### MEMORANDUM

**SUBJECT:** Compark Village South Major Amendment-Belford Ave and Bridge (SP21-028)

## SITE IMPROVEMENT PLAN - AMENDMENT NO. 1

## Belford Avenue Streetscape Conceptual Planting Design

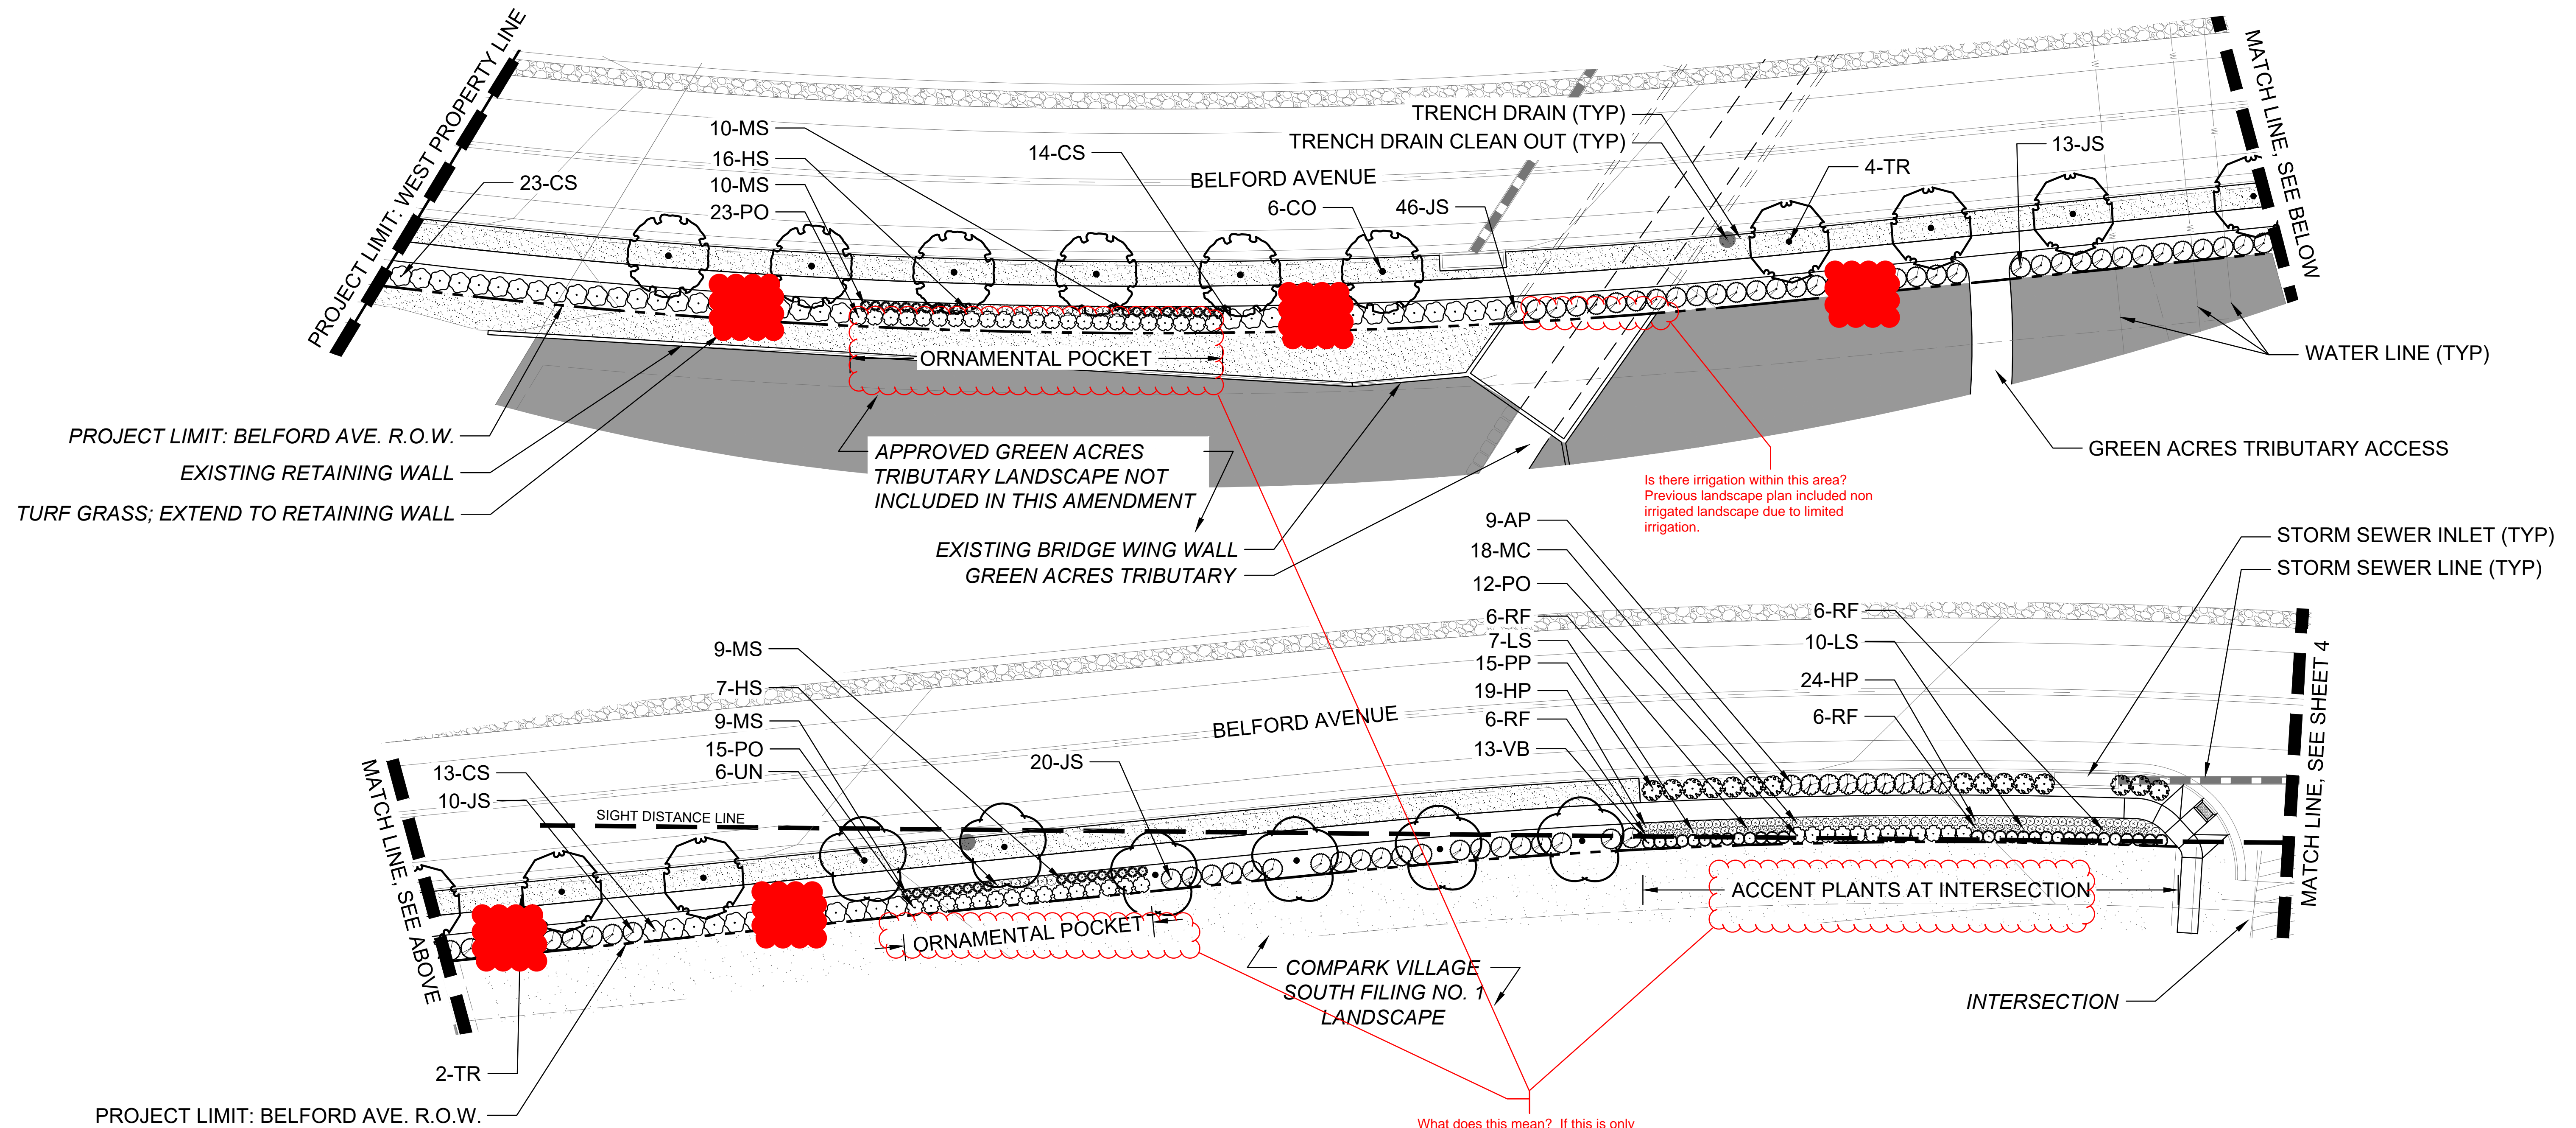
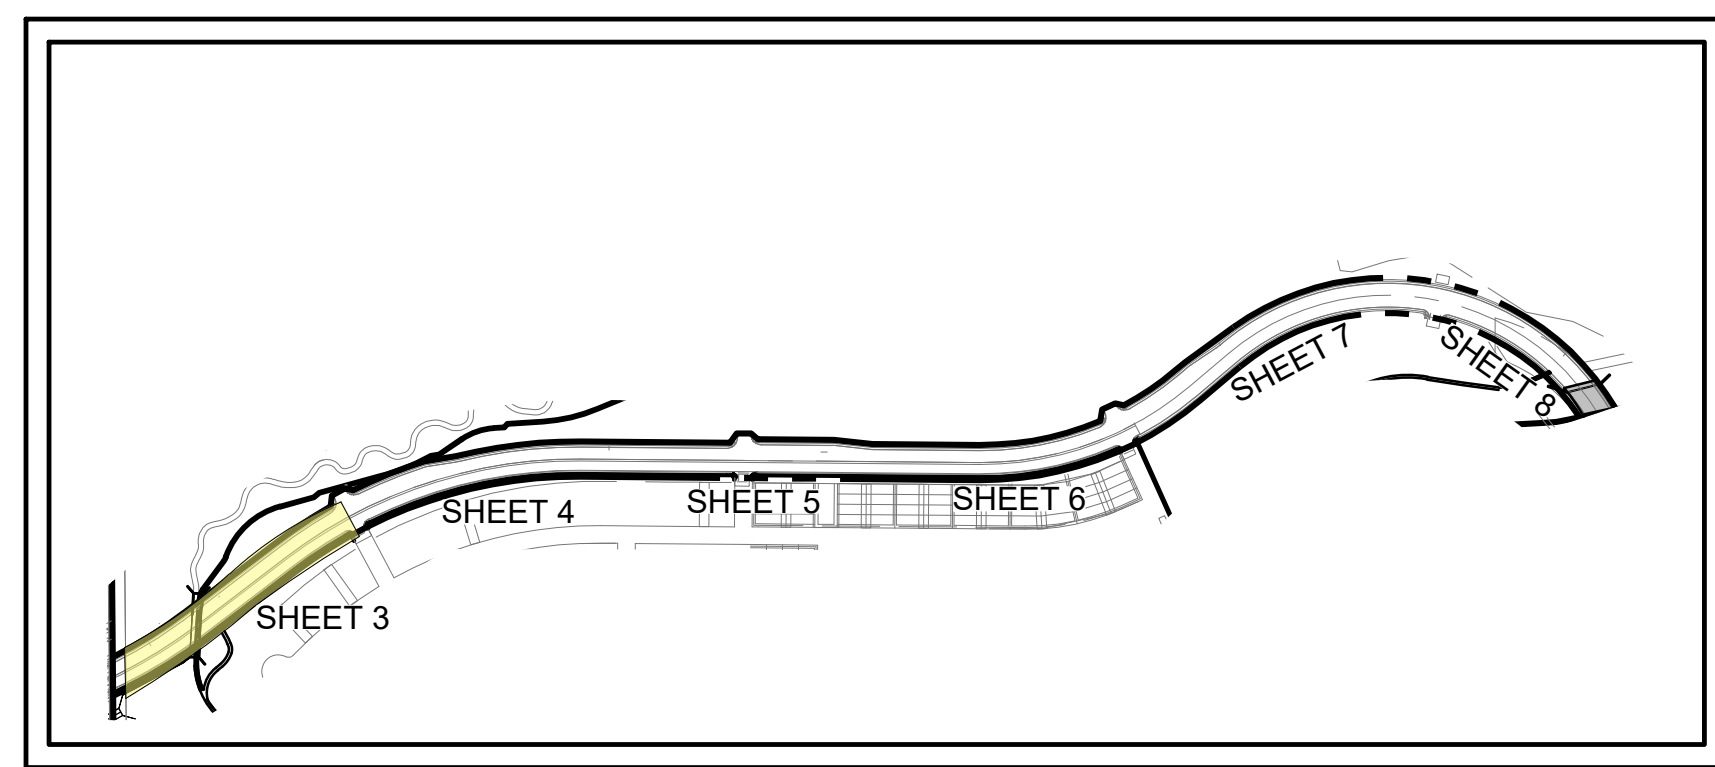
Please add additional trees at these locations to help meet the intent of the previous approved plan. In addition, the original landscape plan included 29 trees. The current plan within these areas only has 18. The addition of these trees can help meet the original, plus the intent.

Is there irrigation within this area? Previous landscape plan included non irrigated landscape due to limited irrigation.

What does this mean? If this is only describing what is being planted, please remove to avoid confusion. If this is for additional landscaping, all landscaping needs to be a part of this plan and shown or grayed back and stated part of a different plan. Adding this wording is not an option.

## Belford Avenue Streetscape Conceptual Planting Design Site Improvement Plan Amendment No. 1

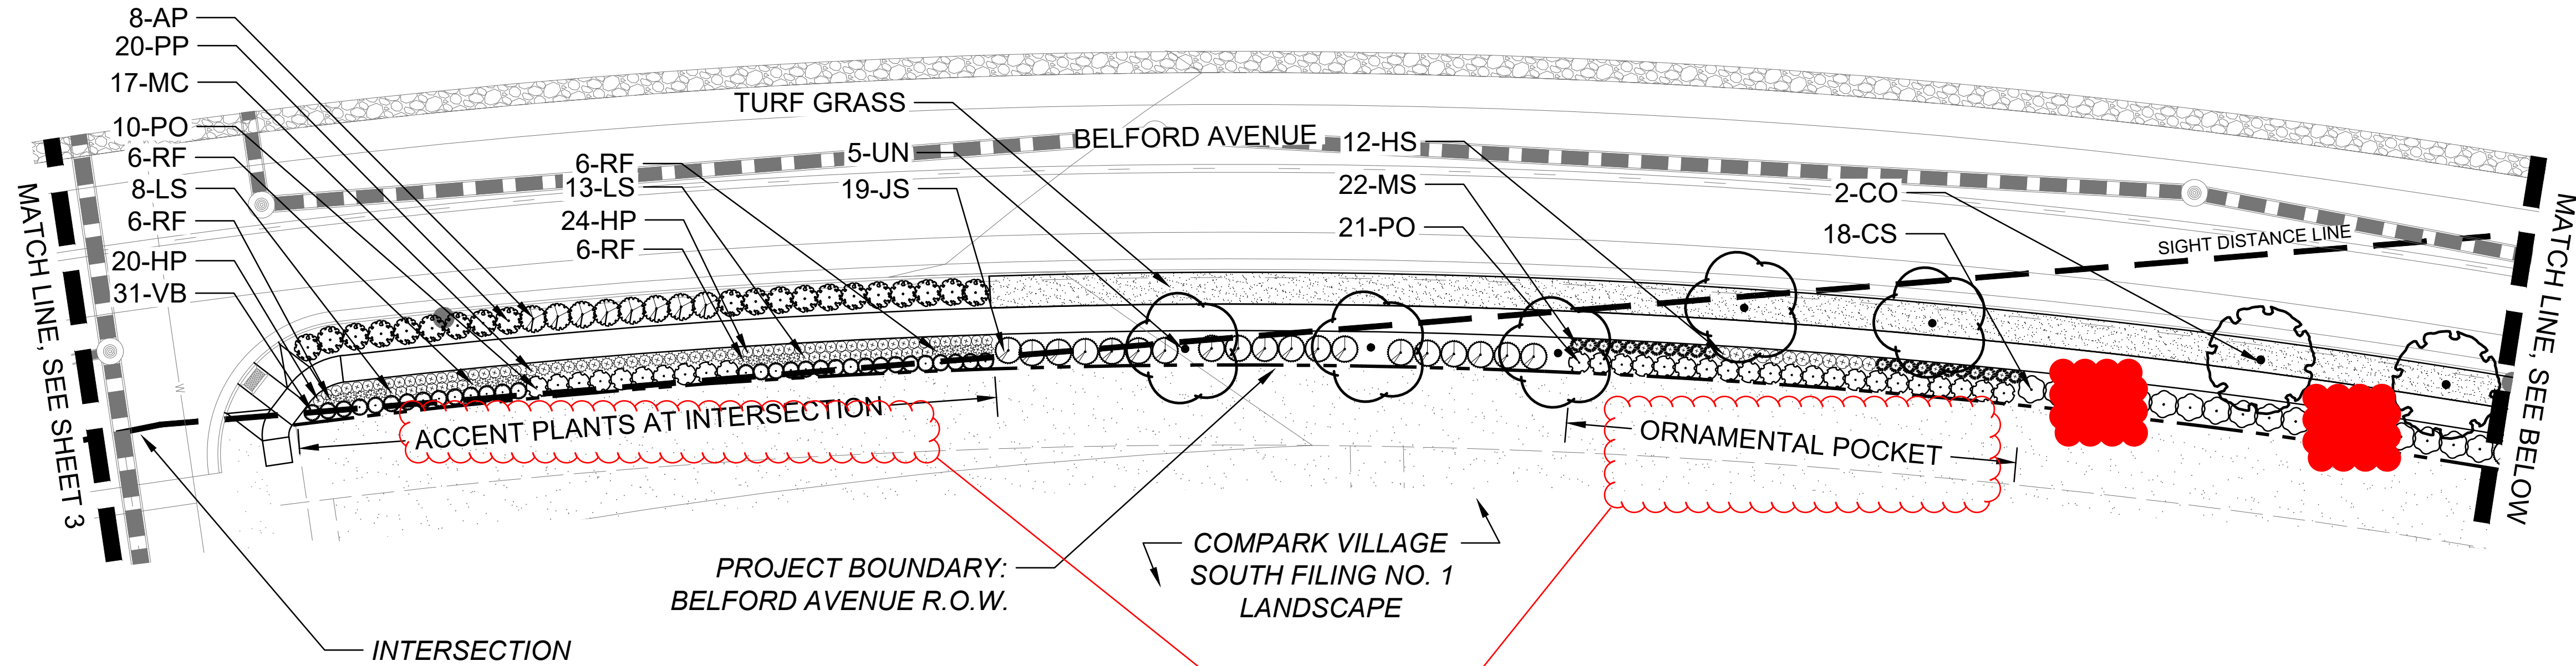
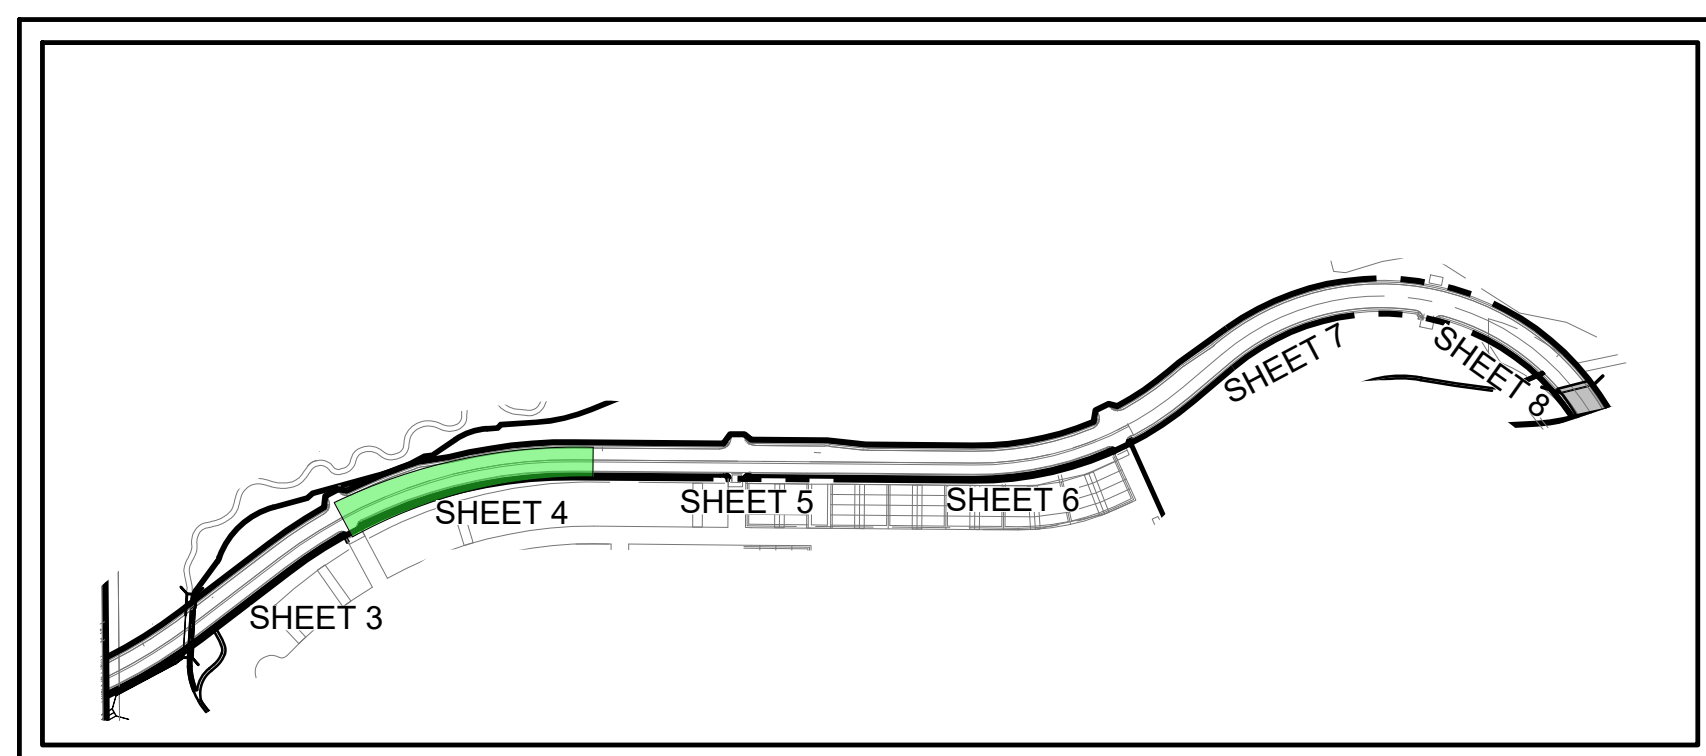
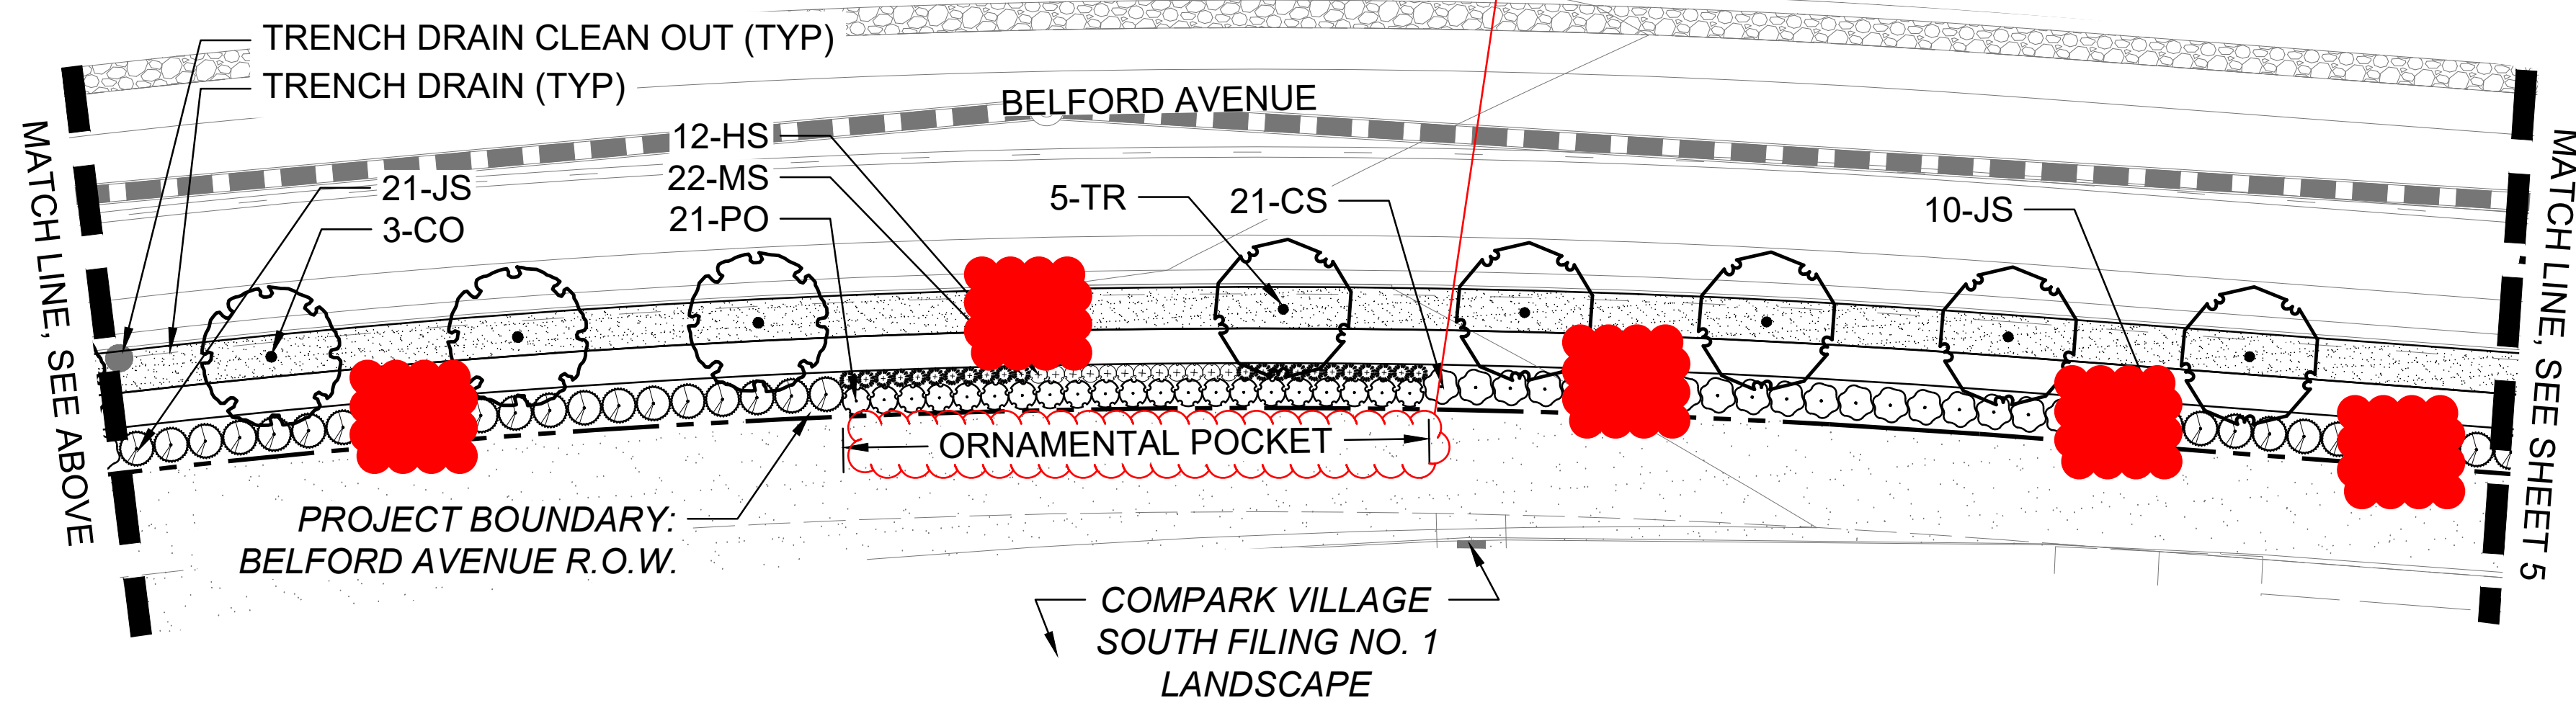
See previous page for why additional trees should be added at these locations.

See previous page comments on these notes.
